SUNDRY NOTICES AND REPORTS ON WELLS
Do not use this form for proposals to drill or to re-enter an abandoned well. Use Form 3160-3 (APD) for such proposals.

Old Ranch Canyon "7" Federal #4

At this time Devon request changes in the intent to deepen the Old Ranch Canyon "7" Federal #4 as follows.

DEVON ENERGY CORPORATION WELLBORE SCHEMATIC

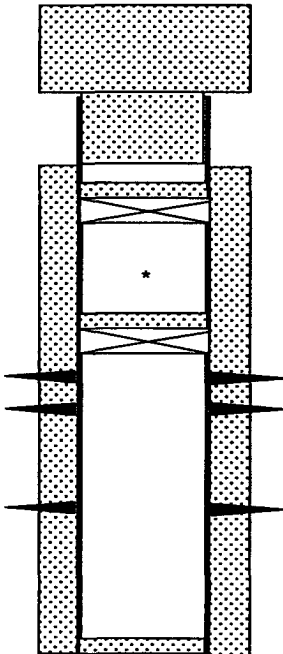
1. Top of kick off plug at $\pm 4,700'$ with the 7" casing stub cut at $\pm 5,000'$ (300' in and out plug spotted from 5,300', TOC behind the 7" casing at 5,300'). There will be a CIBP at 5,500' and at 8,000' each capped with 35' of cement. Please see the attached well bore schematic of the proposed procedures.

2. Instead of the previously requested 5 1/2" liner in the 6 1/8" or 6 1/4" hole (drilled out of the 7" casing stub), run 4 1/2" 13.5# L-80 LT&C liner $\pm 8,300'$ to ETD 10,000', and cement with approximately 241 sx Class H bringing the top of cement to the top of the liner.
